Work Order ID 165165

DART SERVICE INSTRUCTION

TO AMEND INSTALLATION INSTRUCTIONS IIN-D117-762 REV. E AND
INSTRUCTIONS FOR CONTINUED AIRWORTHINESS ICA-D117-762 REV. 4

A	NEW ISSUE	RF	17.01.09
REV.	DESCRIPTION	BY	DATE
DESIGN	RF	DART AEROSPACE, LTD EUGENE, OR	
DRAWN	RF		
CHECKED	WK	DRAWING NO.	REV.A
MFG. APPR.	N/A	DSI 9771	SHEET 1 OF 2
APPROVED	HS	TITLE	SCALE
DE APPR.		GHL UPGRADE KIT	NTS
DATE	17.01.09	COPYRIGHT ©2017 BY DART AEROSPACE USA, INC THIS DOCUMENT IS PRIVATE AND CONFIDENTIAL AND IS SUPPLIED ON THE EXPRESS CONDITION THAT IT IS NOT TO BE USED FOR ANY PURPOSE OR COPIED OR COMMUNICATED TO ANY OTHER PERSON WITHOUT WRITTEN PERMISSION FROM DART AEROSPACE, LTD.

FIGURE 1 - GHL UPGRADE INSTALLATION

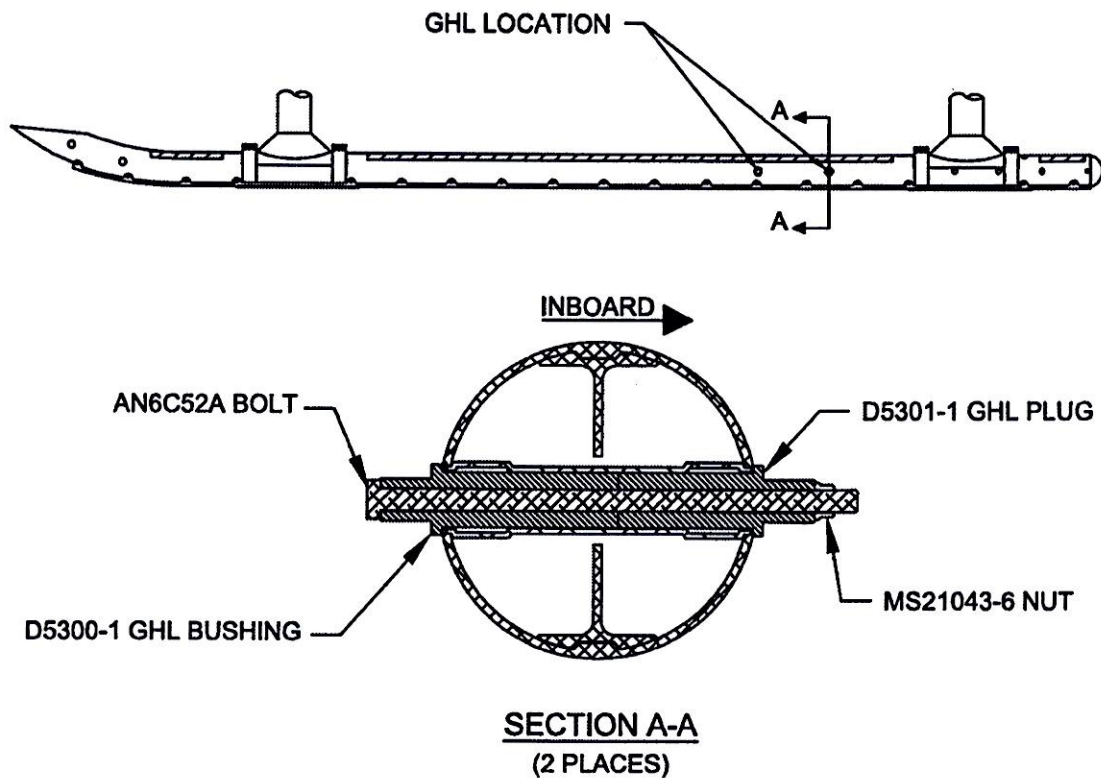
The purpose of this Dart Service Instruction (DSI) is to replace the ground handling lugs (D3864-1 Bushings, AN6C51A Bolts and MS21043-6 Nuts) on the D117-762-XXX Skidtubes with a structurally superior lug design (D5300-1 Bushings, D5301-1 Plugs, AN6C52A Bolts, MS21043-6 Nuts) as shown in Figure 1. The new hardware will be included in D117-762-011 @ CHG 004 and subsequent.

- 2.1 Loosely install (qty 2) D5300-1 GHF Bushing & (qty 2) D5301-1 GHF Plug wet with Proseal 890 or MIL-S-8802 Class B2 Sealant in location shown in Figure 1.
- 2.2 Install (qty 2) AN6C52A Bolts and (qty 2) MS21043-6 Nuts in accordance with Figure 1. Clean up squeezed out Proseal and apply fillet seal around D5300-1 & D5301-1.
- 2.3 Torque AN6C52A Bolts 160 - 190 in-lbs (18.1 - 21.5 N-m).

ITEM	QTY -011	PART NUMBER	DESCRIPTION
	X	D117-762-011	SKIDTUBE INSTALLATION
50	2	AN6C52A	BOLT
51A	2	D5300-1	GHF BUSHING
51B	2	D5301-1	GHF PLUG
52	2	MS21043-6	NUT

ITEM	QTY -011	PART NUMBER	DESCRIPTION
	X	D117-762-011	SKIDTUBE INSTALLATION
50	2	AN6C51A	BOLT
51	4	D3864-1	BUSHING
52	2	MS21043-6	NUT
